Carmichael Coal Mine and
Rail Project SEIS
Volume 3 Rail Studies

5 November 2013

Figure 1
Page 3 of 4

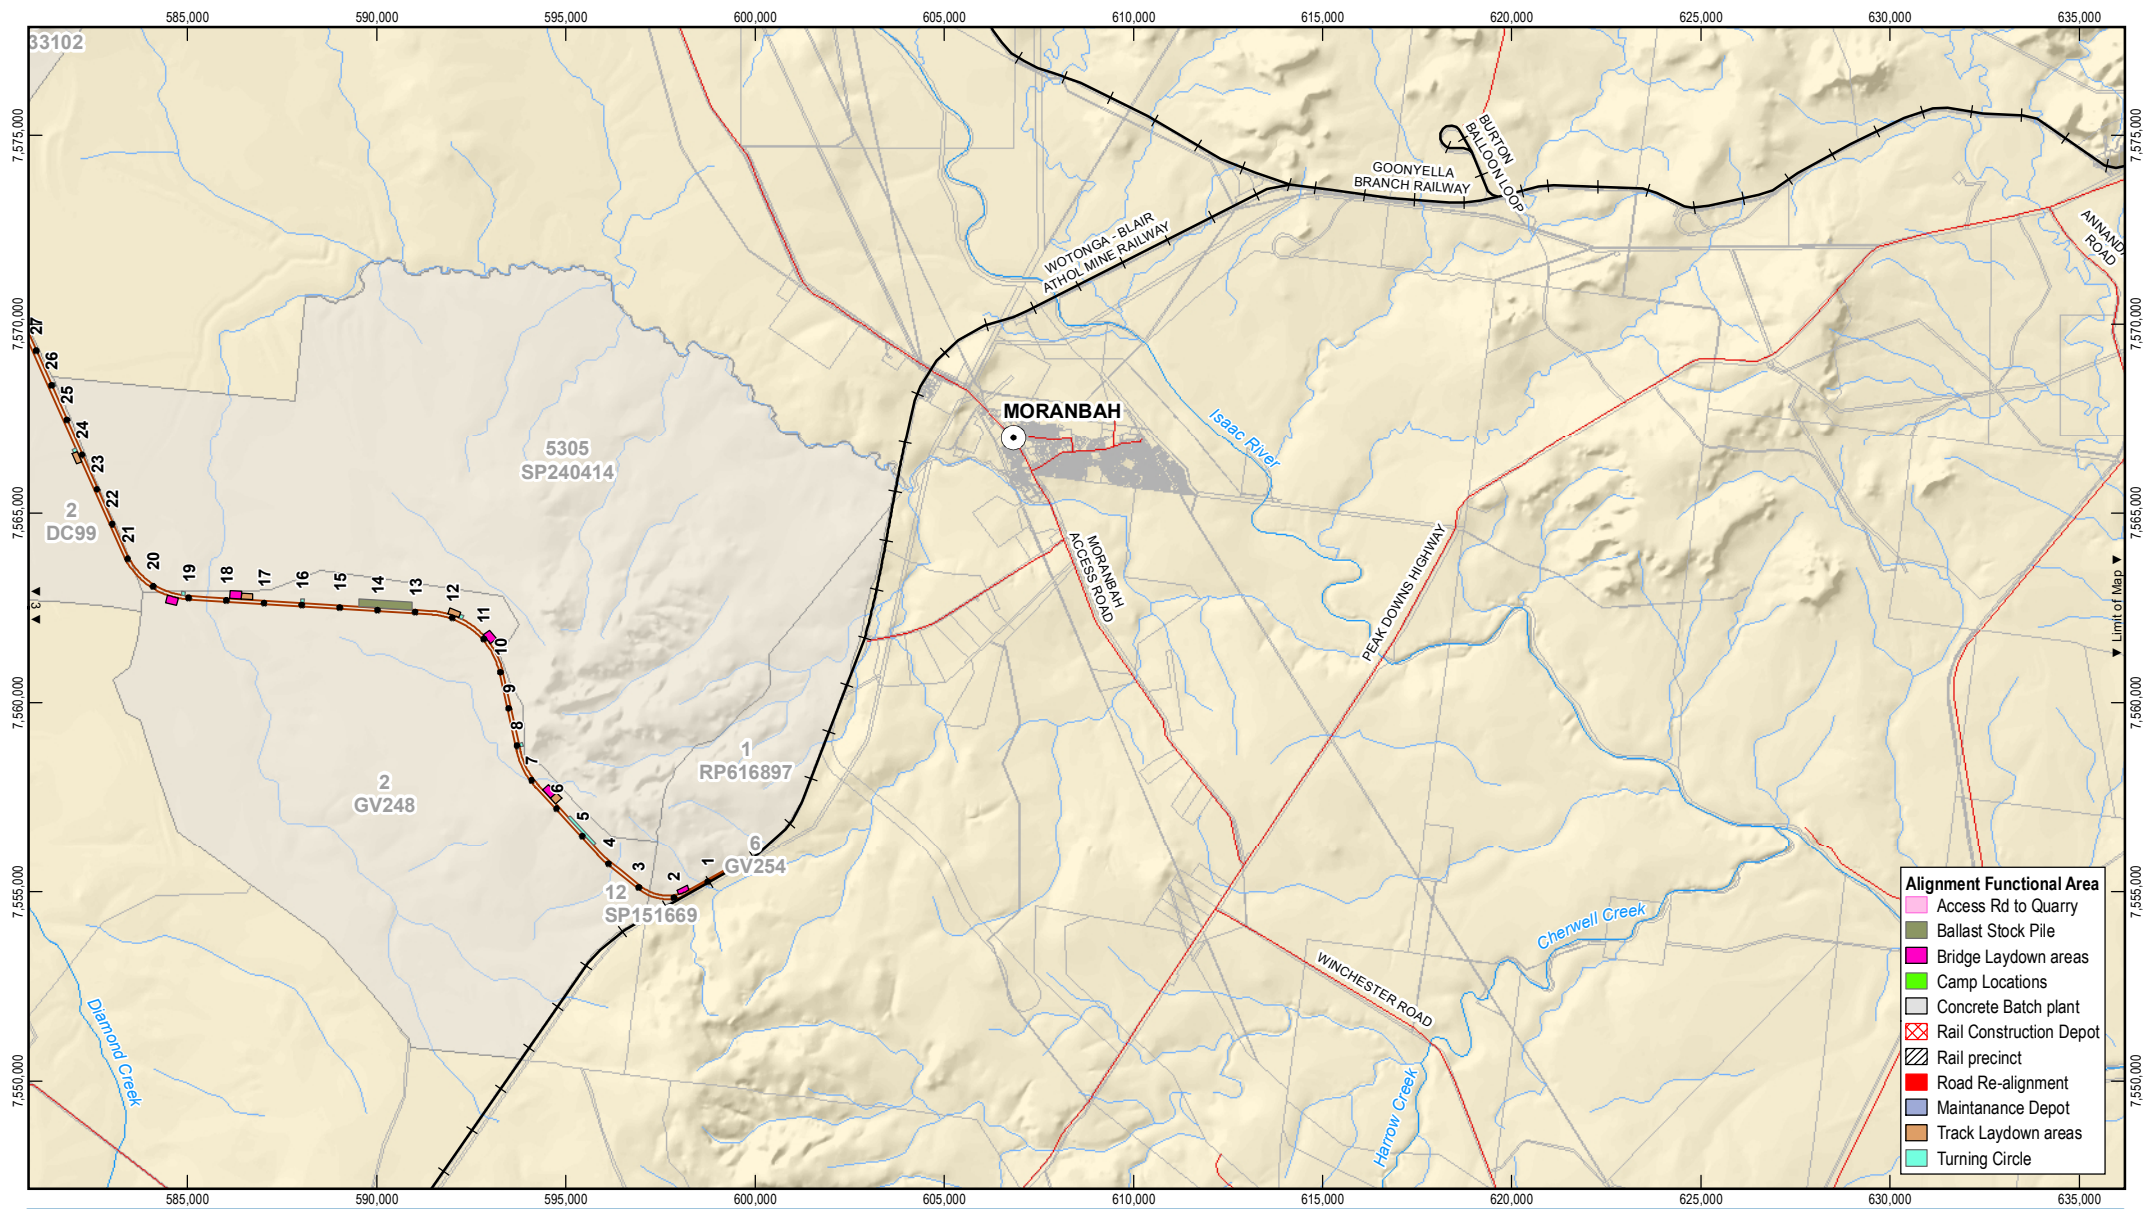
The following sections highlight amendments to the initial Project (Rail) description that have occurred in the SEIS phase of the Project (Rail). All amendments have been identified in Figure 1.

The rail balloon loop located on Lot 662 PH1491 has been realigned approximately 2 km to the south east (from Eight Mile Creek) following a review of the mine product stockpile configurations and coal handling plant. As part of the realignment, the following associated rail infrastructure was realigned:

- Concrete batching plant at Chainage 182.500 in the EIS was removed
- Bridge laydown at Chainage 175.500 was reorientated 50 m south
- Turning circle (Chainage 176.000) was moved 400 m east to be adjacent to the bridge laydown areas
- Turning circle (Chainage 175.400) was moved 375 m south east onto the stem of the new loop

Figure 2

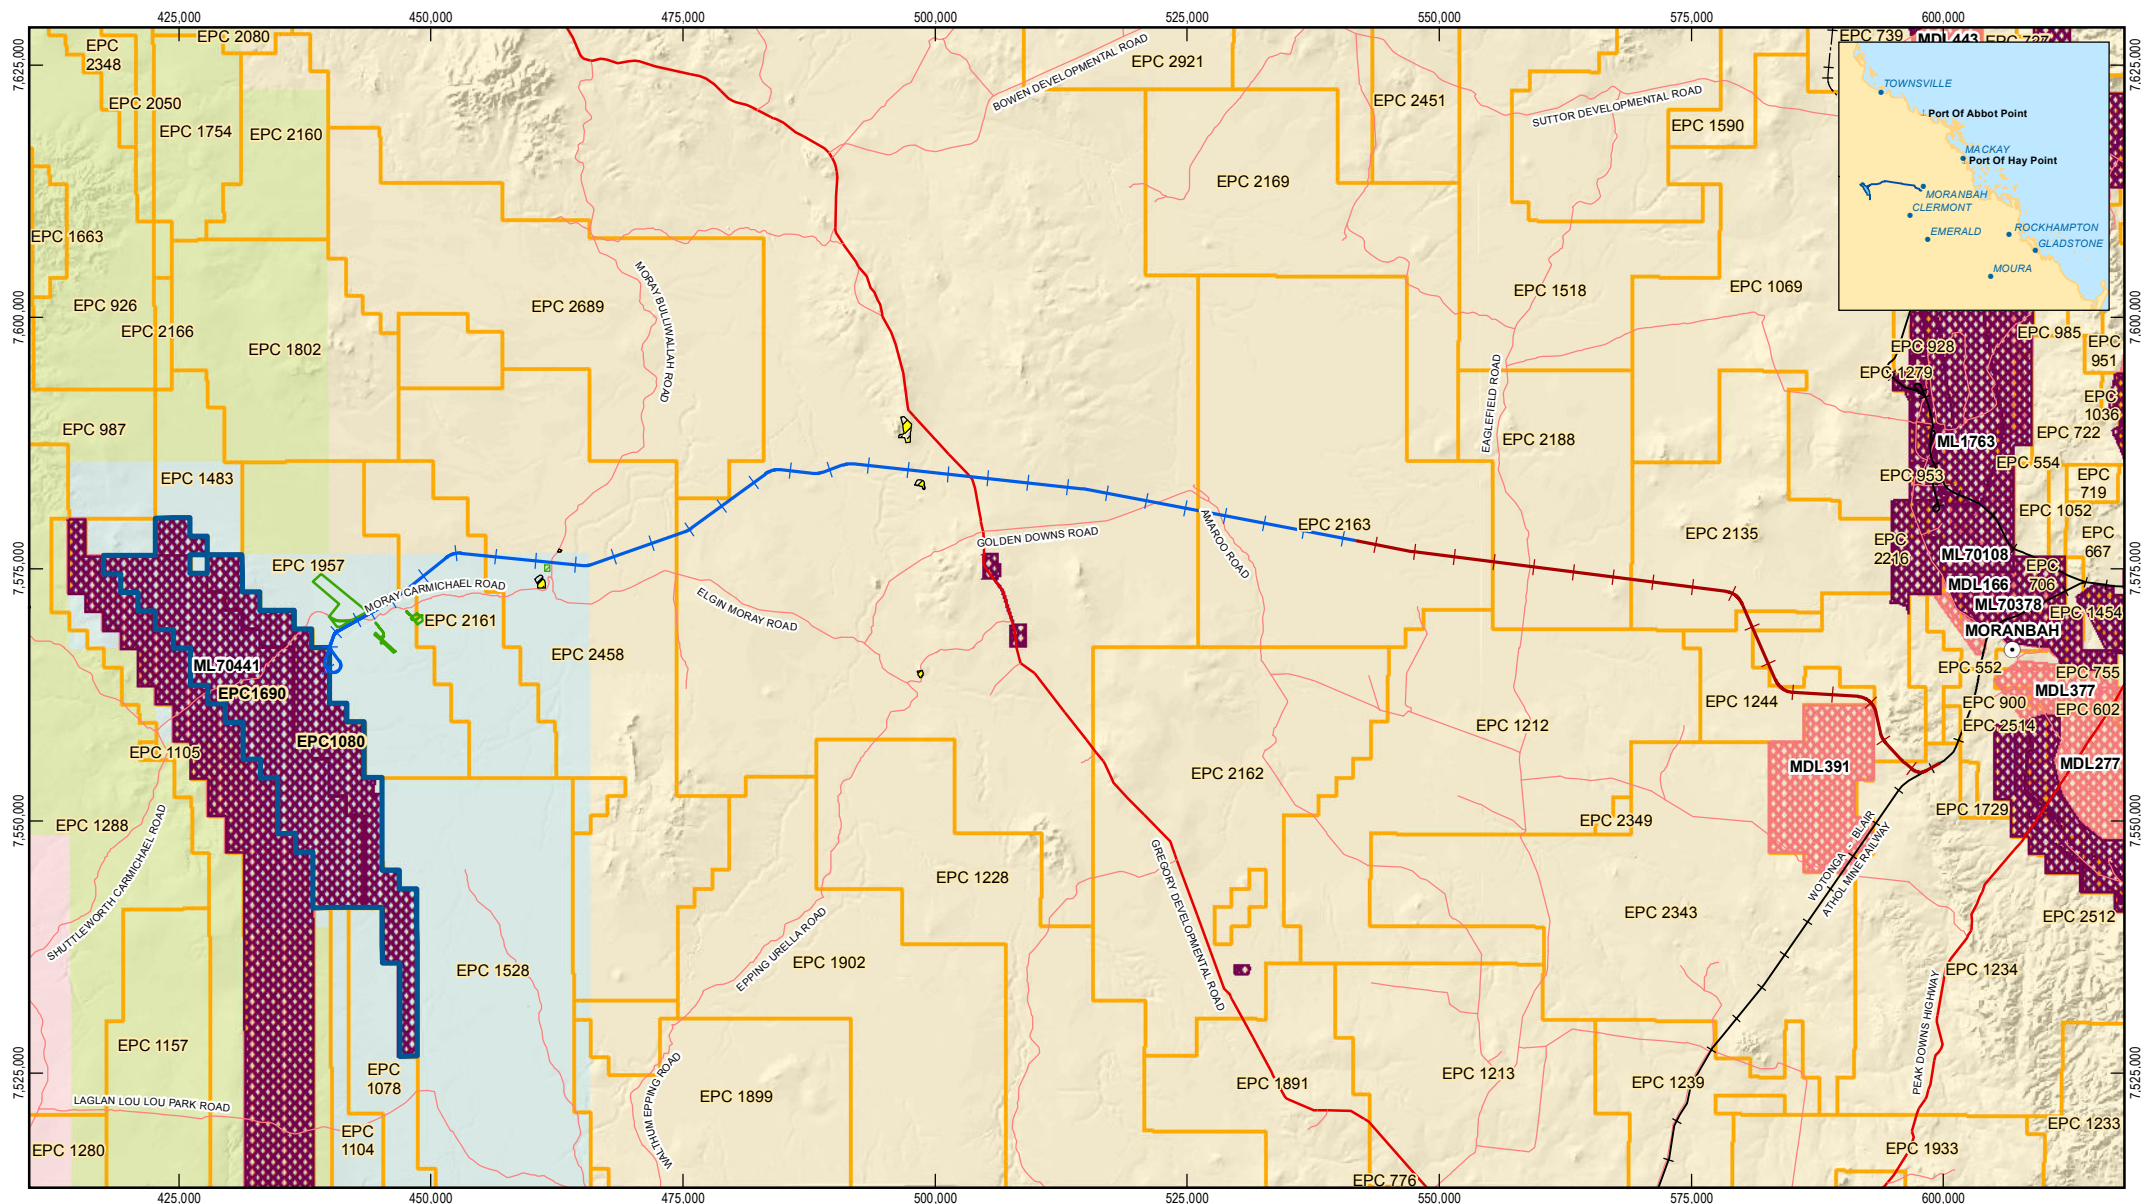
DNRM have commented that there are an additional ten Exploration Permits for Minerals (EPM) that are not mentioned in the EIS and that the impact of the proposed rail line on these tenures should be considered by the proponent included in any table/figure that show the current tenures.

The mining and petroleum tenure figure and table have been updated to include the EPMs that will be traversed by the rail corridor (refer to Figure 2 and Table 6). Consultation between Adani, DNRM and the relevant tenure holder will be undertaken.
